This errata sheet provides updated information on known device issues affecting Cyclone® IV devices.

Table 1 lists specific Cyclone IV issues, and which Cyclone IV devices are affected by each issue.

Figure 1. Programmable PPM Detector Options in the ALTGX MegaWizard Plug-In Manager

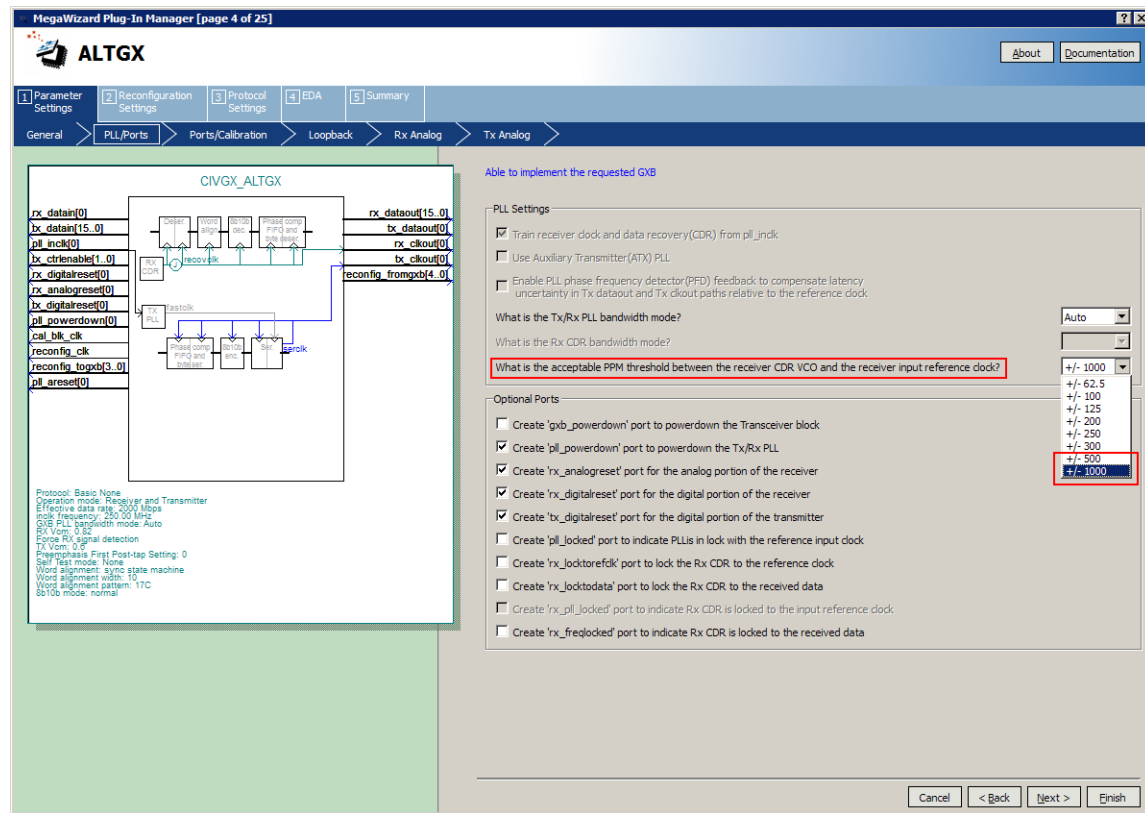
The ±500 PPM and ±1000 PPM options for the Programmable PPM Detector feature in the ALTGX MegaWizard™ Plug-In Manager, as shown in [Figure 1](#), are no longer supported in the Quartus II software version 10.0 SP1 and later. These options are removed because the programmed PPM threshold values exceed the receiver CDR PPM tolerance between the upstream transmitter reference clock and the local receiver reference clock.

Designs compiled with the Quartus II software version 10.0 and earlier may have a link failure risk when the receiver is operating in a system that has ± 500 PPM or ± 1000 PPM differences for the reference clock frequencies between the upstream transmitter and the local receiver. Using CDR Manual Lock mode does not overcome the link failure risk.

For a receiver design that has the ± 500 PPM or ± 1000 PPM options selected in the Programmable PPM Detector feature, Altera recommends evaluating the system operation with different options, ranging between ± 62.5 PPM and ± 300 PPM. To change the **Programmable PPM Detector** option, regenerate and recompile the ALTGX MegaWizard Plug-In Manager design file with the supported options.

If you compiled your designs using a Quartus II software version prior to 10.0 SP1, and you have selected the ± 500 PPM or the ± 1000 PPM option for the Programmable PPM Detector feature, the Quartus II Analysis and Synthesis error will be reported in the Quartus II software version 10.0 SP1 and later.
